GOVERNMENT OF THE DISTRICT OF COLUMBIA  
DEPARTMENT OF GENERAL SERVICES

**Addendum No. 03**  
**To**  
**Invitation for Bid (“IFB”) No. DCAM-20-CS-IFB-0004**

**MPD Blue Plains Impound Lot Modernization**

**Questions & Answers Spreadsheet**

**C - 300**

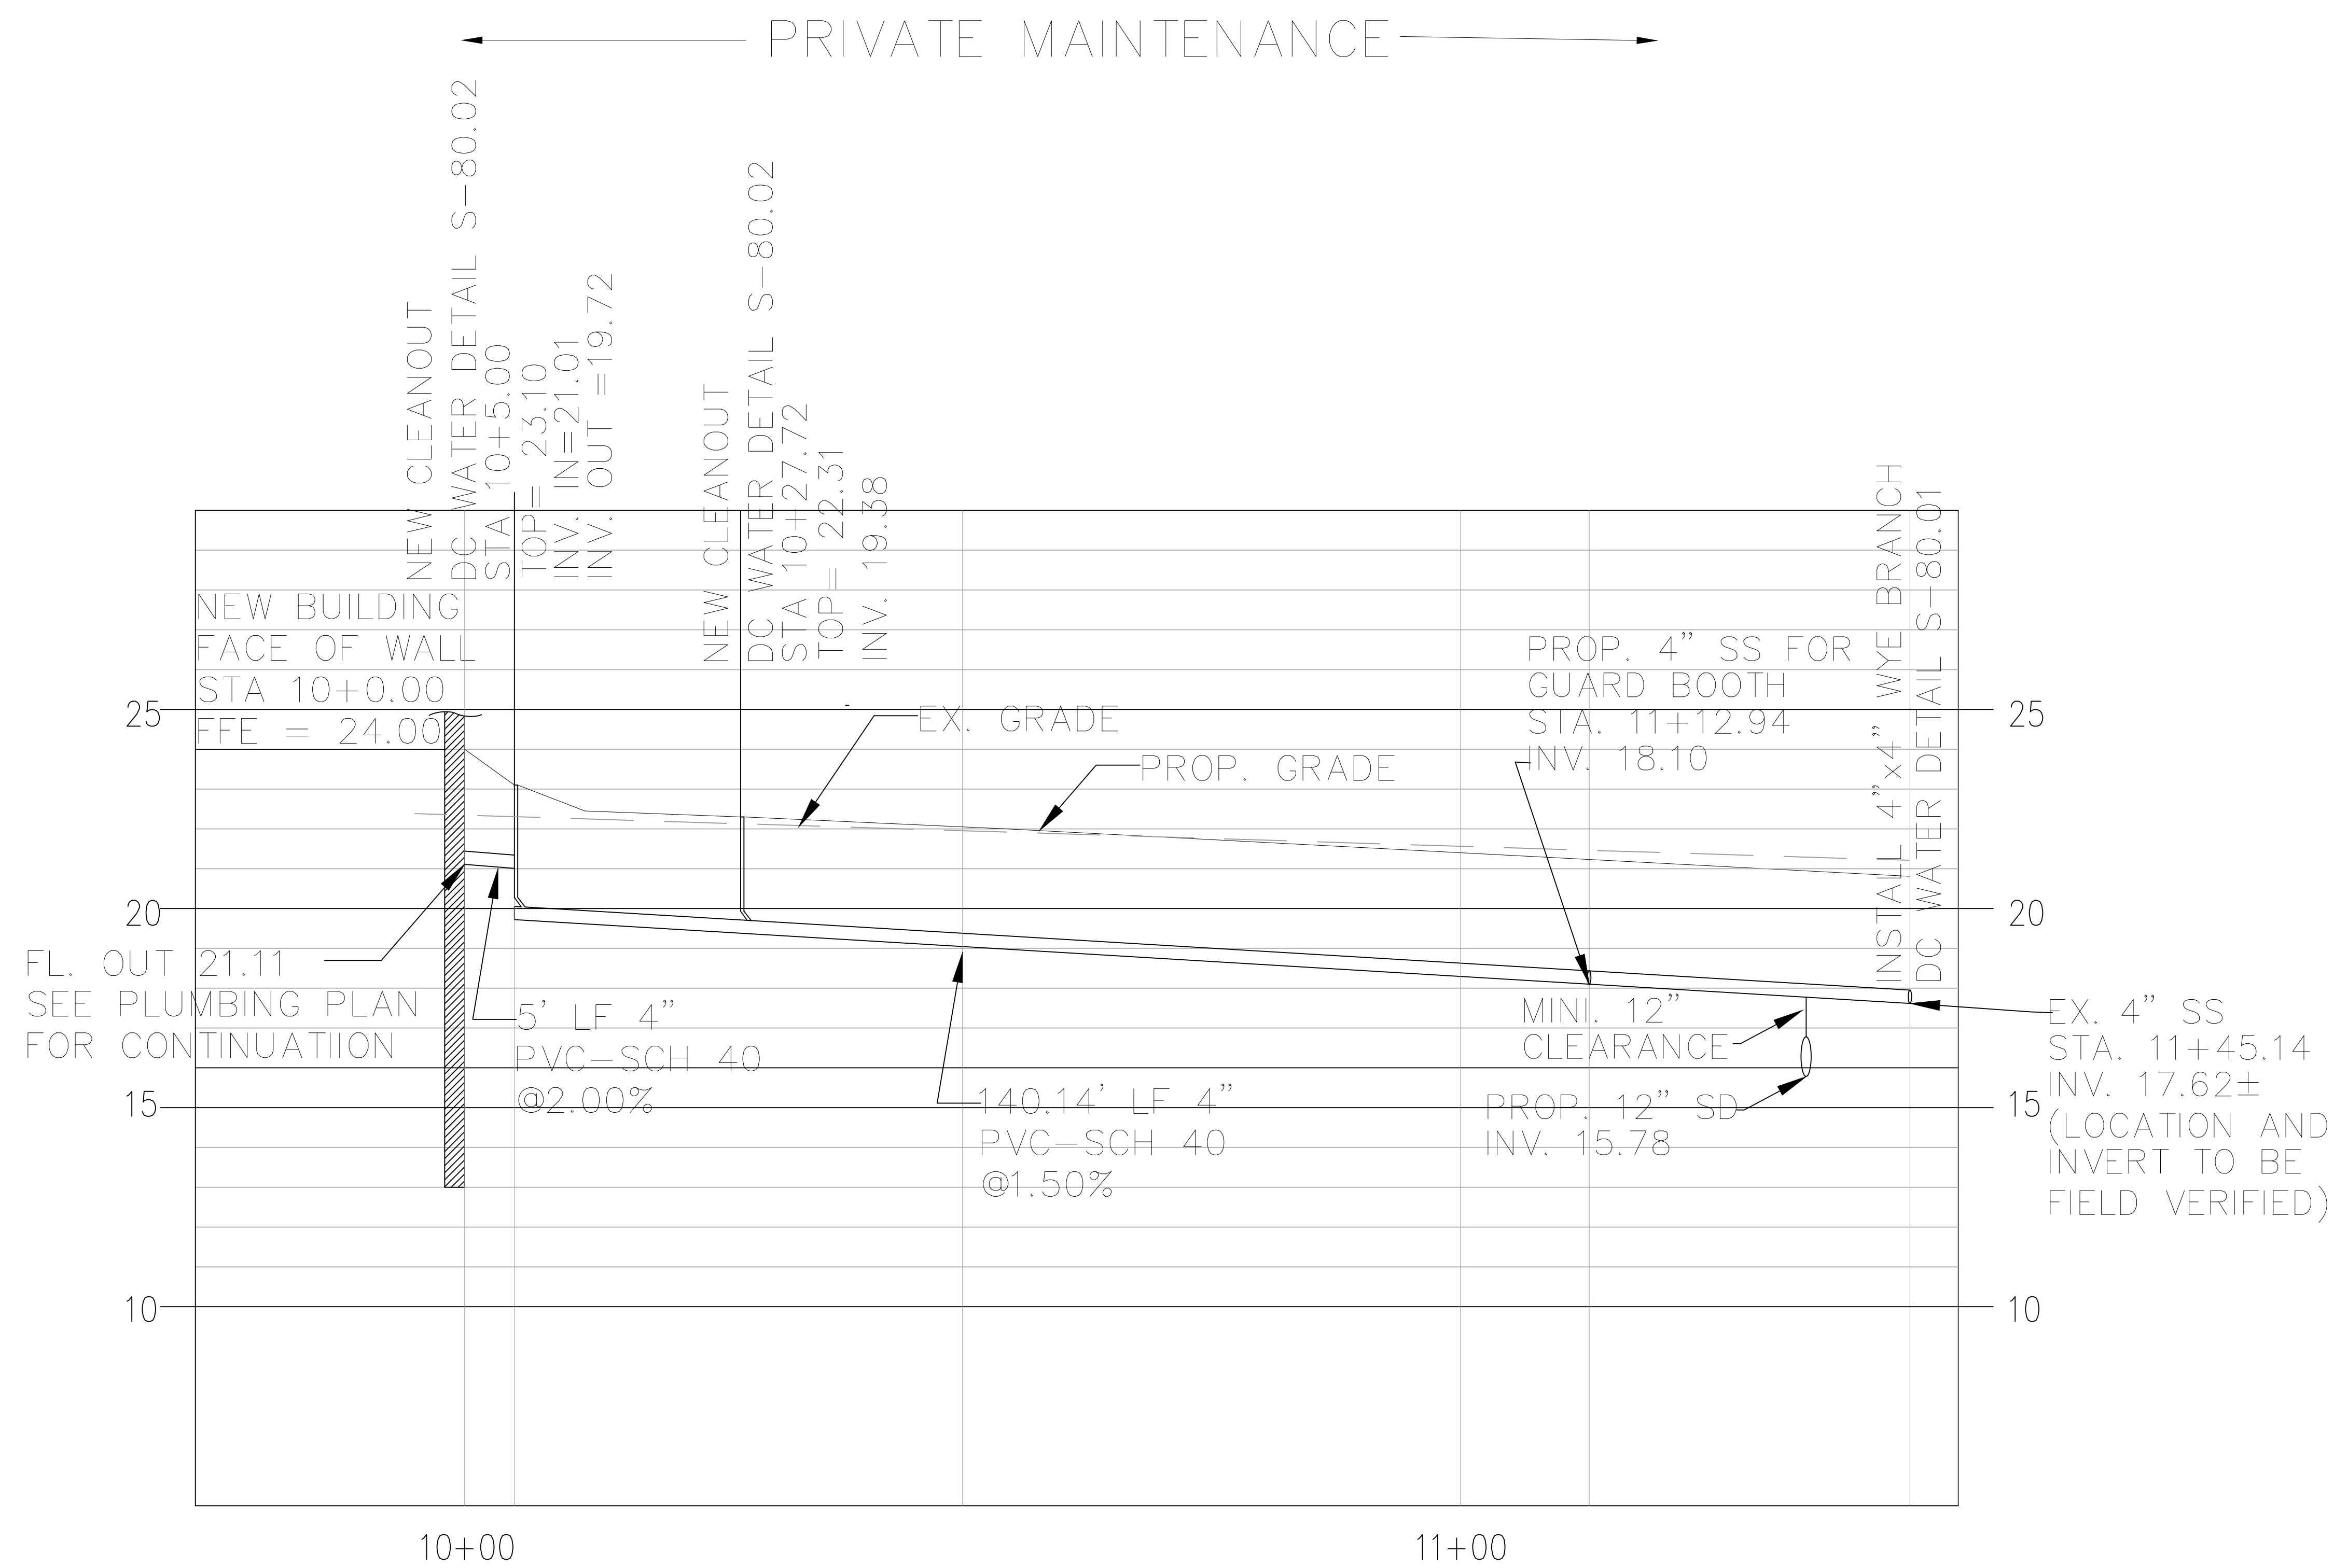
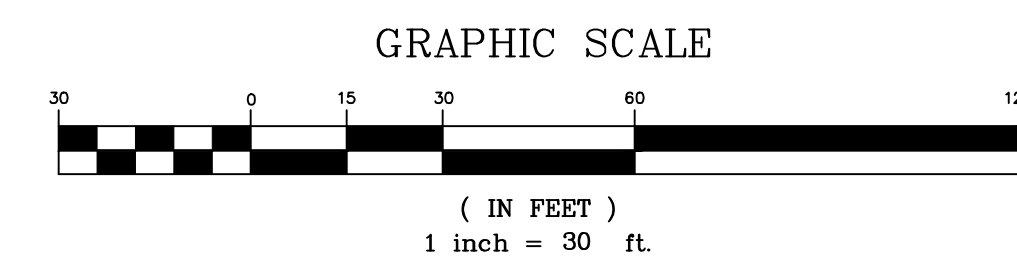
17	<p>Reference is made to the Guard Booth on plan sheet A 101. The manufacturer was listed as below</p> <p>"GUARD BOOTH BASIS OF DESIGN: PORTA-KING BUILDING SYSTEMS (MODEL: DURASTEEL PC-DAR157SL POC: MATT McNAMEE PHONE: 636-549-3605, EMAIL: <a href="mailto:MATT@RACKANDSHELF.COM">MATT@RACKANDSHELF.COM</a>, WEB: <a href="http://WWW.RACKANDSHELF.COM">WWW.RACKANDSHELF.COM</a>)."</p> <p>We have contacted them but they are not fabricating that type structure any longer. Does DGS/MPD recommend another alternative?</p>	<p>There is an error on our construction documents, Matt McNamee is with Rack and Shelf. The correct information for the guardbooth is below</p> <p>Matt w / Portaking 800.456.5464 ext 261 mhodges@portaking.com</p>
18	Is the guard shack part of the bid package?	Yes.
19	There's no striping plan provided either. Please make sure the engineer or architect provides that to us	See sheets C-300 & C-301.

24	The specifications spell out chain link fence, the drawing note #9 on drawing C-300 mentions match existing metal fence. On this lot they have galvanized chain link, Black vinyl coated chain link and 2 different types of black tubular iron picket fence? Can you clarify which one you wanted quoted for this bid?	The two new gates are chain link fence gate as shown on C303, all new surrounding fence shall match existing 8' high black metal picket fence.
25	Please confirm Commissioning, Otto IT are excluded in scope of work for this project	Commissioning and OCTO is excluded from this SOW and should not be included in bid.
26	Please confirm that permit fee is excluded in this proposal and Projectdocs was completed by other.	Permit fee is paid for by AE, GC to pick up permit only.
27	Please confirm that FF&E and computers stations are not included in scope of work of this bid.	FF&E to be included as indicated on A101. Also see specification Division 10. Computer systems by OCTO.

SHEET TITLE  
**SANITARY SEWER  
PROFILE**

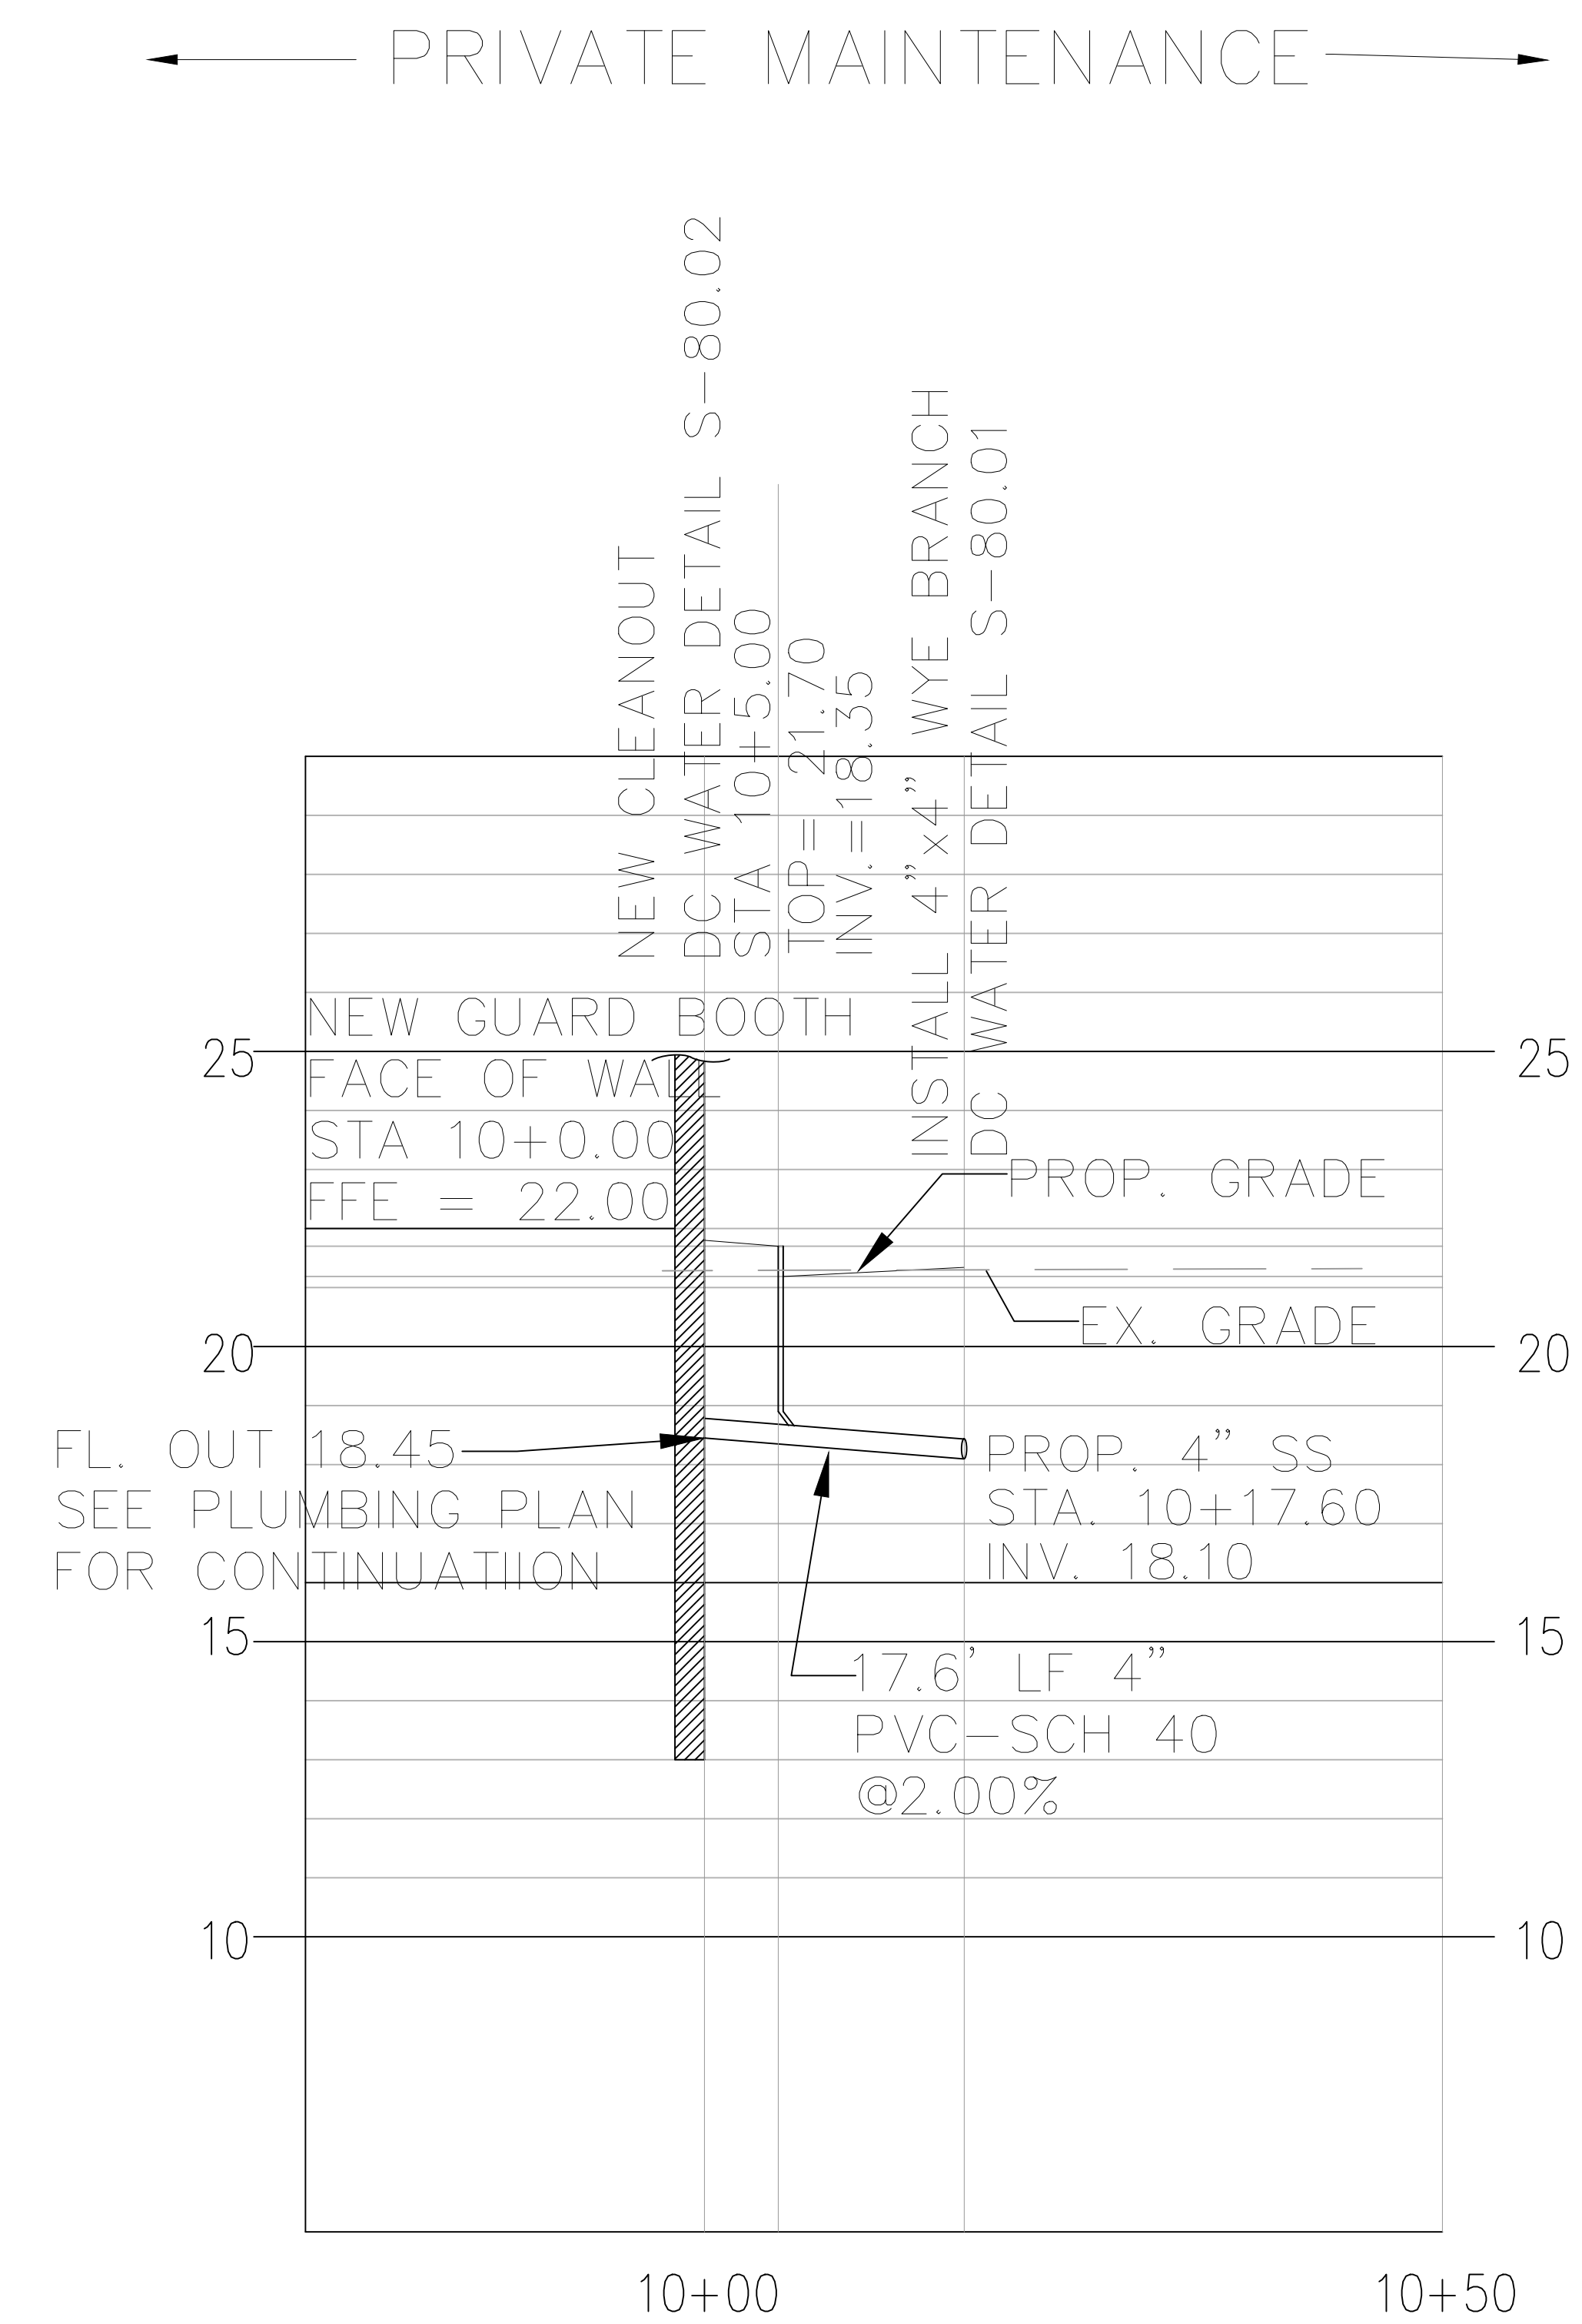
<b>No.</b>	<b>Questions</b>	<b>Department Responses</b>
1	In regards the drawings, we would like to ask about profiles of: a) 1.5” Domestic Water Line b) 4” Sanitary Sewer Line	If the water line less than 2”, DC Water does not require profile. Water line now is 1”, and ¾” for the guard booth. See attached update plans (C-300 & C-305).
2	Please provide light pole and pole base details, there is none provided in the drawing.	Intent is for the foundation design to be delegated to the contractor’s engineer. See specification sections 26 56 00 Exterior Lighting Cast-In-Place and 03 30 00 Concrete.
3	Can you provide the GeoTechnical report to verify if the soil conditions.	Yes, it is contained at the front of the specification book. The separate document is also available.
4	Modular office building per bid documents <ul style="list-style-type: none"><li>o Note 1 – the roof design will not allow it to be transported down the road. It’s too tall.</li><li>o Note 2 – Our supplier, Modular Genius can provide a modular roof to be set on top of the admin office. This would be (4) modular pieces.</li><li>o Note 3 – Our supplier can also provide an alternate to reduce the pitch of the roof so it will ship as one unit. This would be (2) modular pieces.</li></ul>	The design intent was for the roof to be shipped separately. The roof slope shall be as designed.
